APPLICATION NO.	FILING DATE	FIRST NAMED INVENTOR	ATTORNEY DOCKET NO.	CONFIRMATION NO.
09/974,694	10/11/2001	Ronald Paul Rohrbach	H0001541	7962
7590	02/03/2004		EXAMINER	
Honeywell International Inc. Law Department, Patent Services 101 Columbia Road Morristown, NJ 07962			BARRY, CHESTER T	
			ART UNIT	PAPER NUMBER
			1724	
DATE MAILED: 02/03/2004

Office Action Summary	Application No.	Applicant(s)
	09/974,694	ROHRBACH ET AL. 
Examiner	Art Unit	
	Chester T. Barry	1724

FIG. 5

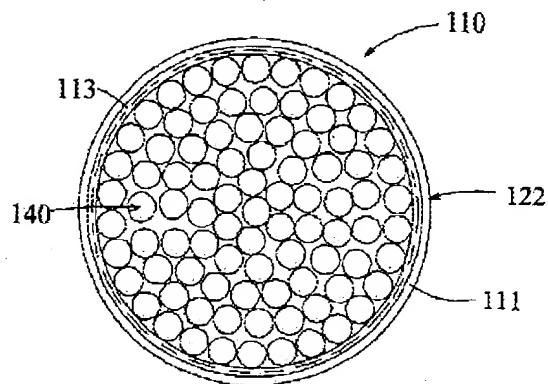
Grieve describes a filter comprising: A hollow housing body defining a chamber therein; an inlet connected to the housing body and in fluid communication with the chamber thereof; an outlet connected to the housing body and in fluid communication with the chamber thereof; and a filter media disposed in the housing chamber, the filter media comprising: a plurality of fibers; and a sulfur-treating composition operatively associated with the fibers. See Grieve's description at paragraph [0040] and Fig. 5 (emphasis added):

Accordingly, claims 1, 2, 7, and 10 - 12 are rejected under Sec. 102(e) as anticipated by Grieve.
